GOLDEN EMPIRE AFFORDABLE HOUSING

ADDENDUM NO. 1

Re: 805 North Chester, Bakersfield Ca 93308

SITE PLAN

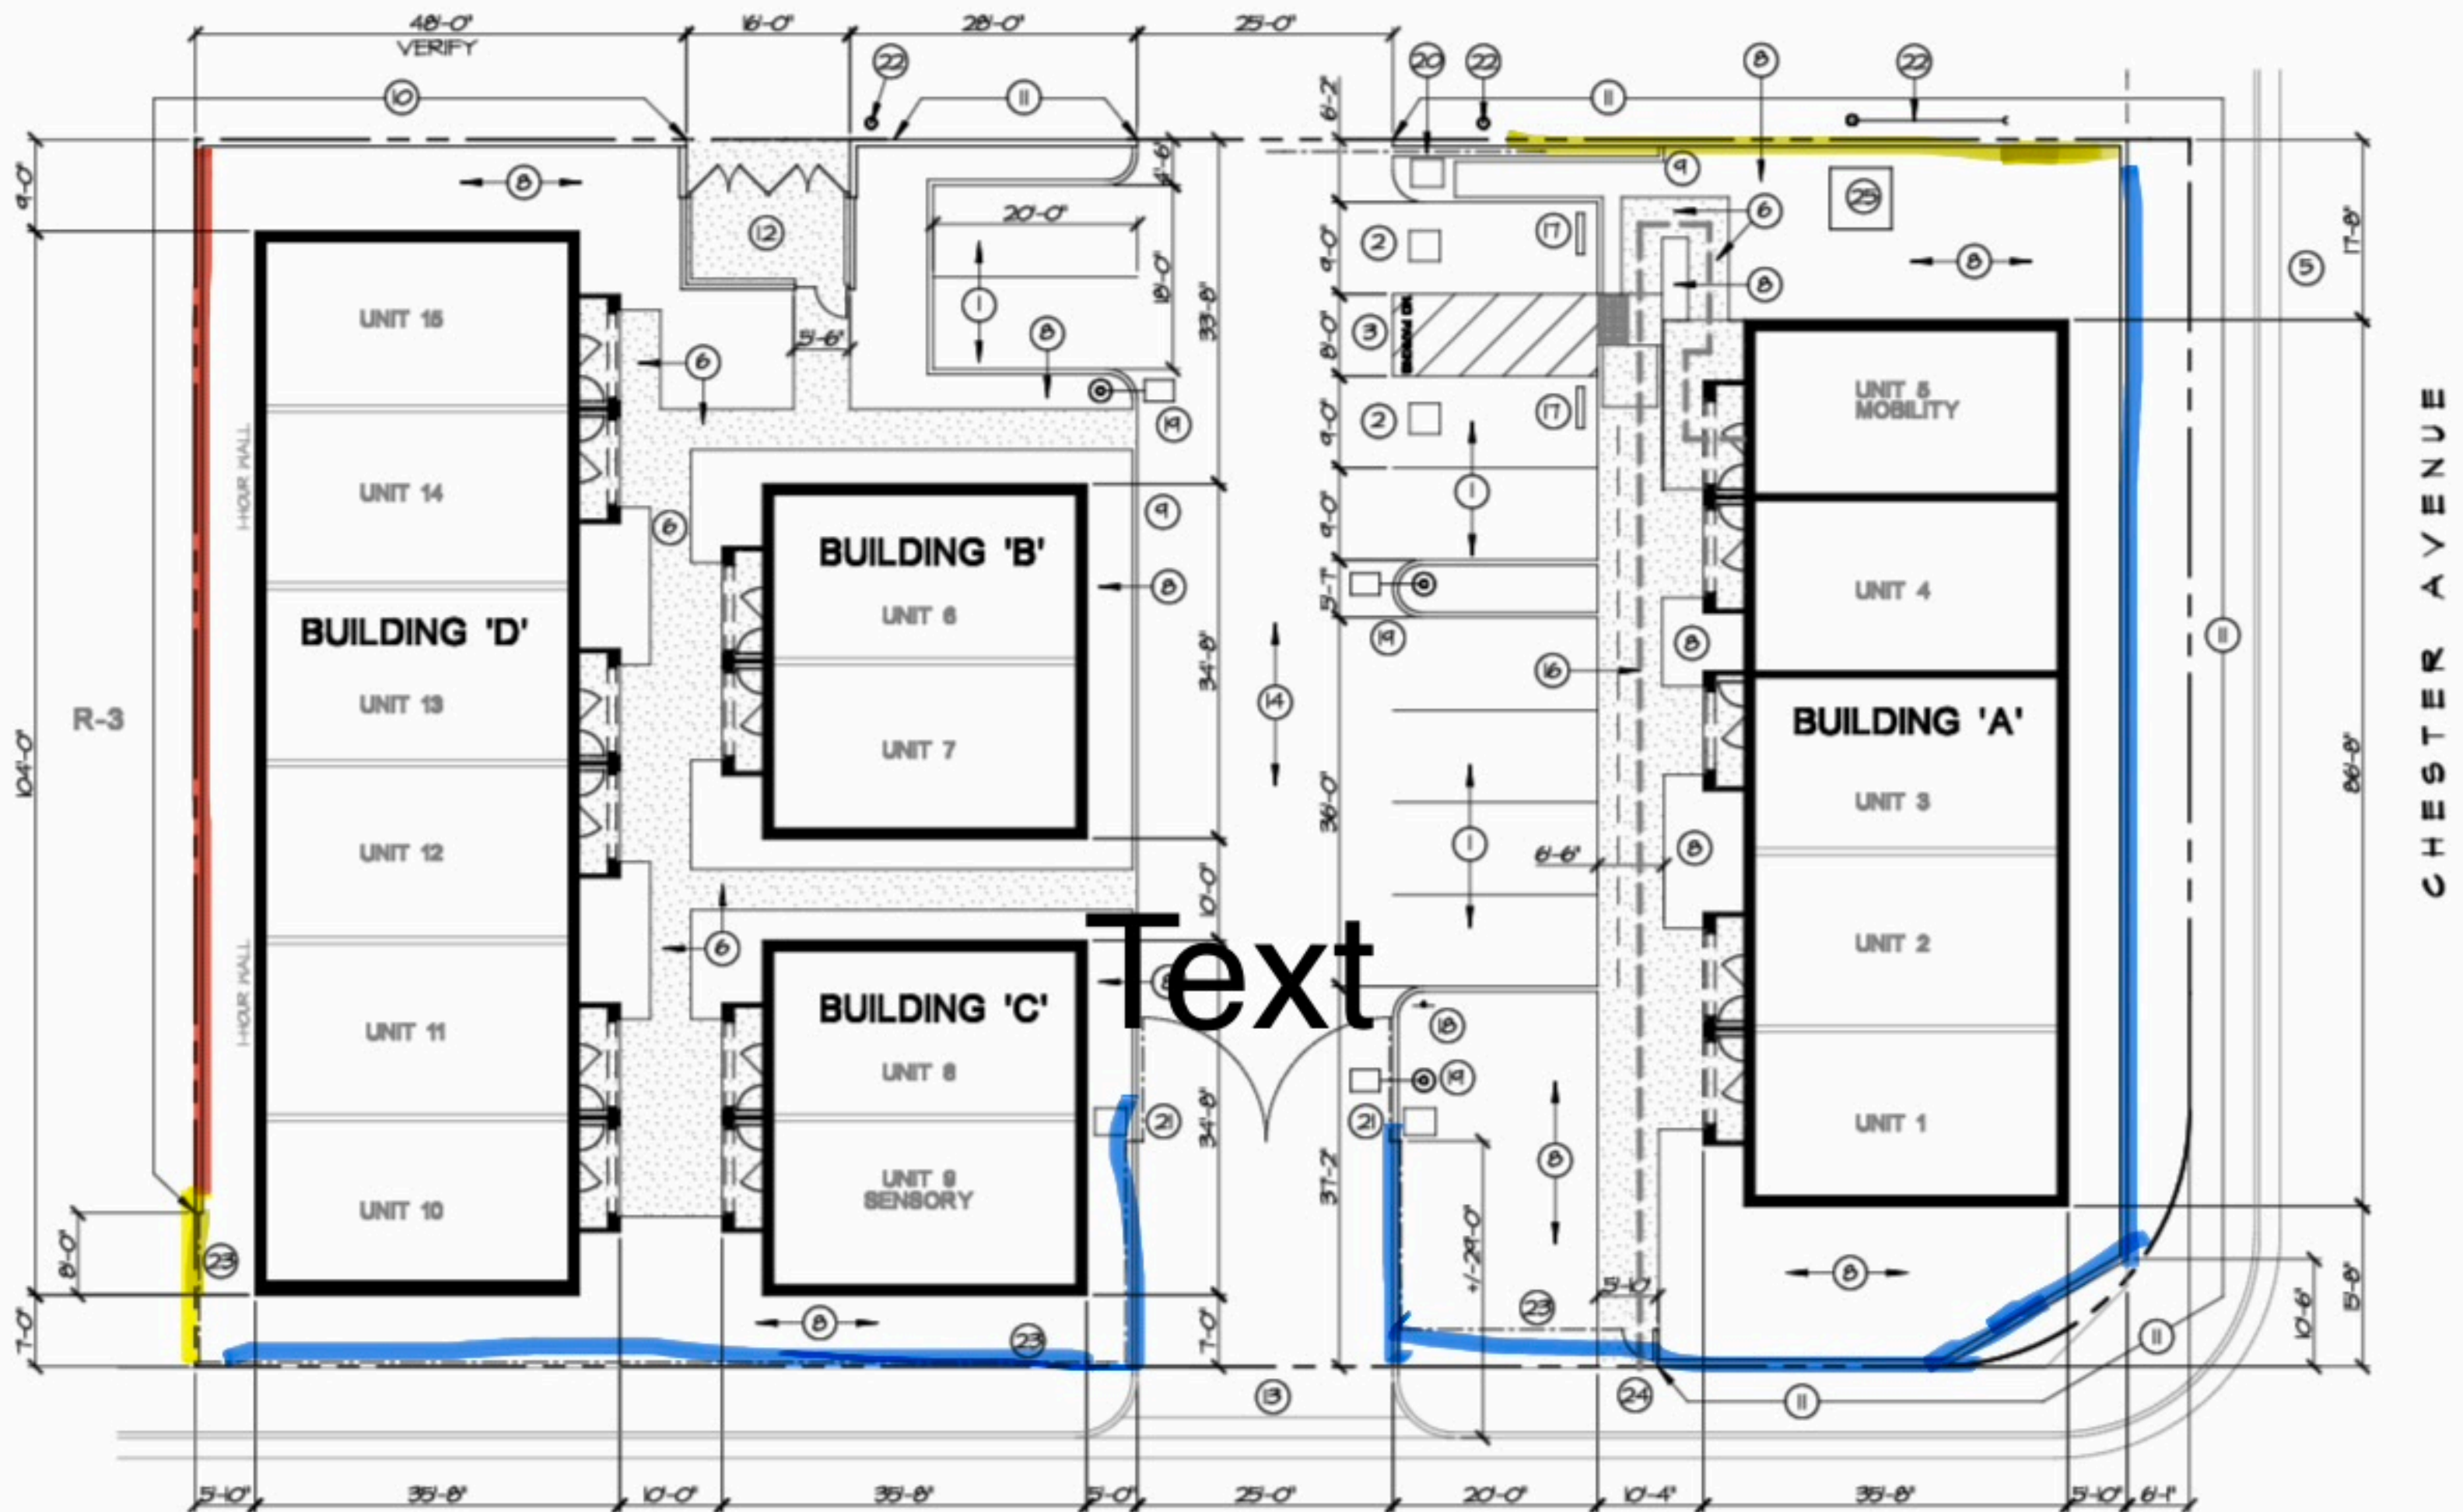
Provide and install approximately **20 linear feet** of new masonry to extend the existing block wall, and add **two (2) additional courses** to the entire existing wall located along the **west side of the property**. Refer to the attached site plan with the affected area highlighted in **yellow and red**.

Provide and install approximately **50 linear feet** of new masonry to extend the existing block wall along the **north side of the property**. Refer to the attached site plan with the affected area highlighted in **yellow**.

Add 2 Courses to the entire existing wall

Extend the existing block wall

Changed from Masonry to Wrought iron
